**Date of Issue:** May 2019

**Addendum Effective Date:** November 8, 2019

**Affected Publication:** API Specification 11AX, *Specification for Subsurface Sucker Rod Pump Assemblies, Components, and Fittings*, 13th Edition, May 2015

## Addendum 1

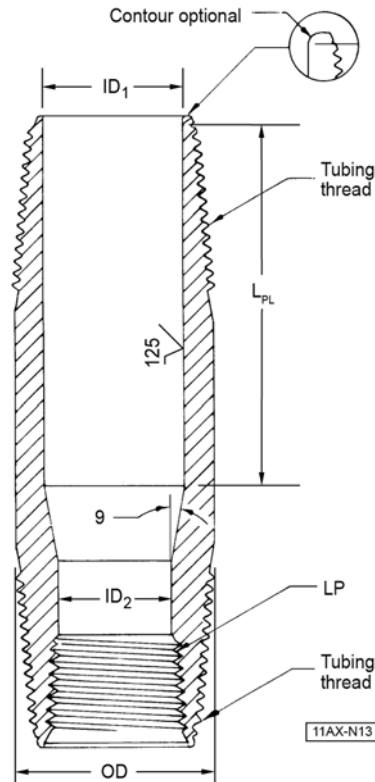
Page 41, Table C.13 shall be replaced with the following:

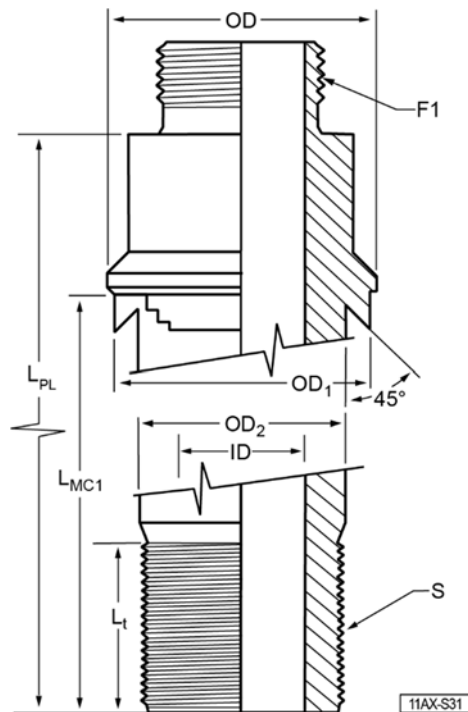
Page 74, Table C.49, shall be replaced with the following:

NOTE Line pipe thread (LP). See API 5B for details.

Page 85, Table C.61, the following rows shall be added below the Alternate Assembly Number part rows:

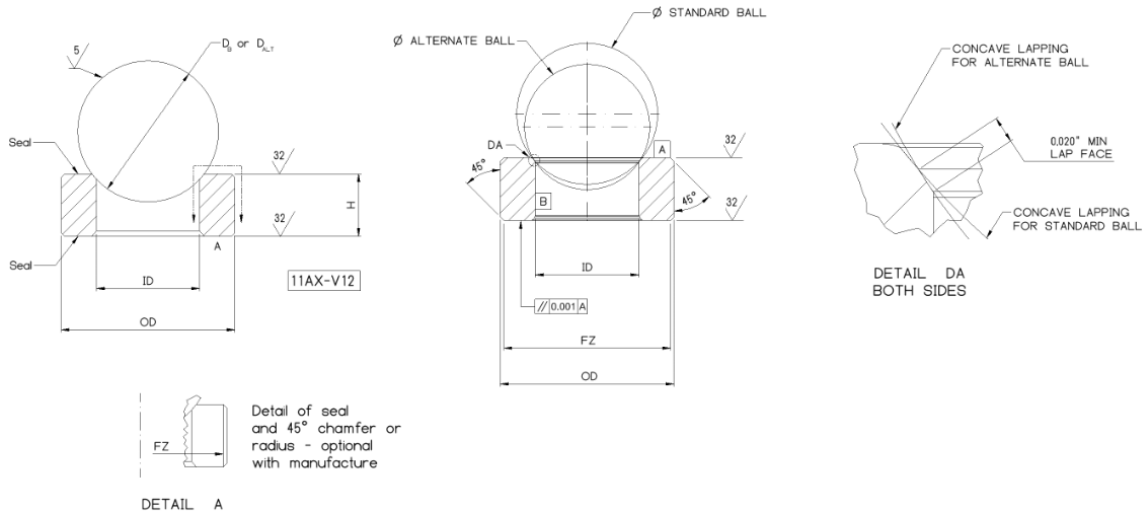
<b>Dual Pattern Assembly Number</b>	V11D106	V11D125	V11D150	V11D175	V11D200	V11D225	V11D250	V11D375
Standard Ball Number <sup>b</sup>	V12-106	V12-125	V12-150	V12-175 <sup>a</sup>	V12-200 <sup>a</sup>	V12-225	V12-250	V12-375
Alternate Ball Number <sup>b</sup>	V12A106	V12A125	V12A150	V12A175	V12-175 <sup>a</sup>	V12-200 <sup>a</sup>	V12A250	V12A375

Page 85, Table C.61, the NOTES shall be updated with the following:

NOTE 1 Ball and seat valves are designed to operate in F22 boxes.

NOTE 2 Each assembly consists of one ball and one seat as shown above.

NOTE 3 The use of alternate (smaller) size balls can damage standard cages during pumping due to the increased ball to ball guide clearance. Alternate ball use requires a seat with a matching alternate seat contact area. Standard ball use requires a seat with a matching standard seat contact area.
